**The 132nd Meeting of State Level Expert Appraisal Committee - 1
held on 4th & 5th August, 2016 at Parishad Sabhagraha, Hall no. 2
& 3, 7th Floor, Main Building, Mantralaya, Mumbai- 400 032.**

Item no. 1	M/s. SEYA Industries Ltd. (ToR) Green field project for manufacturing of synthetic organic chemicals to the extent of 48000 MT/A at D-14, MIDC Tarapur, Boisar, District-Palghar.
-------------------	---

Item no. 2	M/s. Arkema Chemicals India Pvt. Ltd. Proposed expansion project for manufacture of resins amounting to a total of 2670 MT/Month at our existing plot no. D-43/1 & D-43/5, TTC MIDC Shiravane, Thane
-------------------	--

"Annexure 8.2"

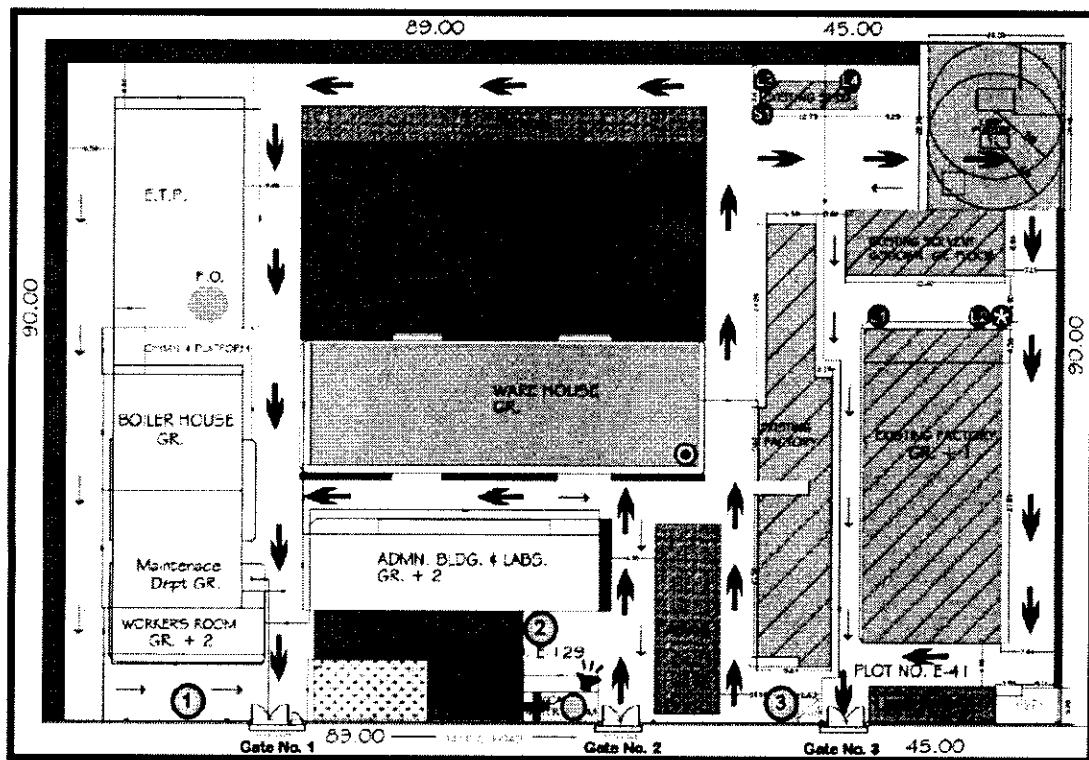
1. The PP needs to provide 12% of layout area for parking. Further facilities for emergency movement of vehicles, evacuation in times of hazard have to be put in place. The hazard management infrastructure like fire water tanks, fire hydrants, assembly points, detectors etc. need to be provided. All these aspects are depicted in the diagram (enclosed as *Annexure 8.2*) and should be in place before commissioning the expansion.
